SECTION H

Copies of Written Comments

Subject: Notice of Preparation of a Draft Environmental Impact Report (EIR)/Environmental Impact Statement (EIS)/EIS for the Upper Truckee River and Marsh Restoration Project, South Lake Tahoe, California

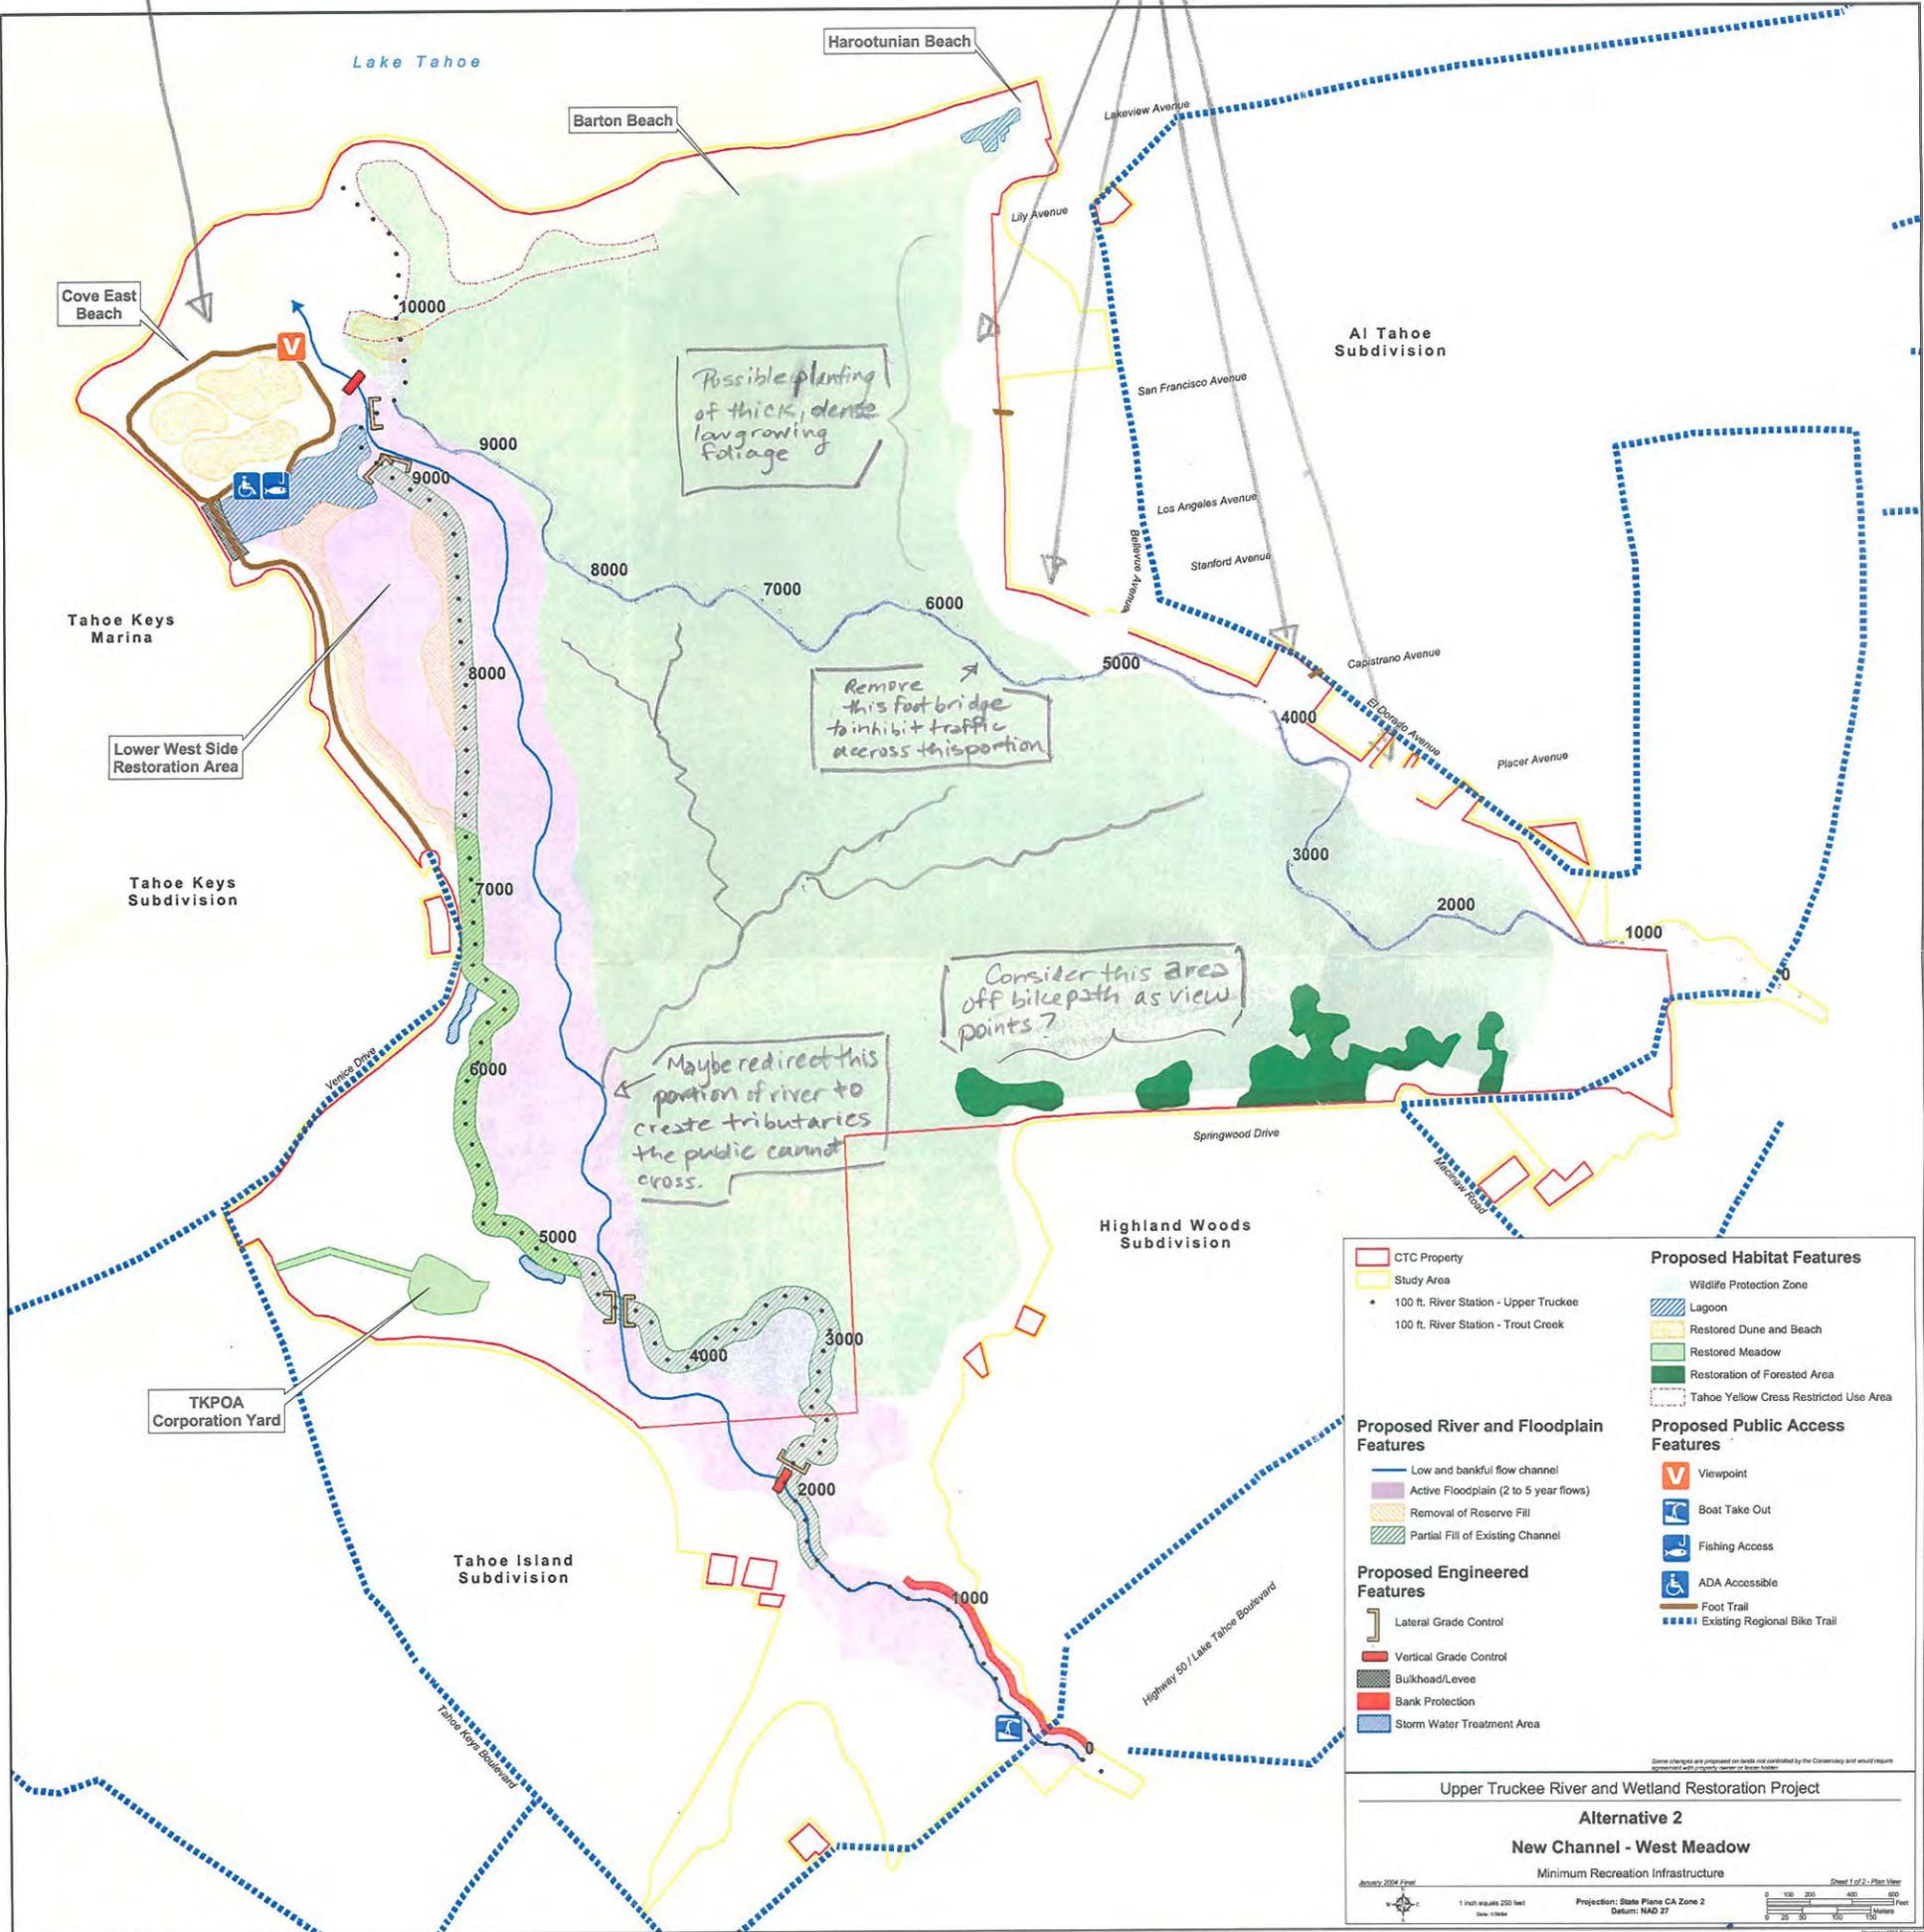
- Plant low growing brush along portion of meadow (see map).

Seriously consider this area for public access with parking and restroom facilities.

Remove all viewpoints

Possible planting of thick, dense lowgrowing foliage

Remove this foot bridge to inhibit traffic across this portion
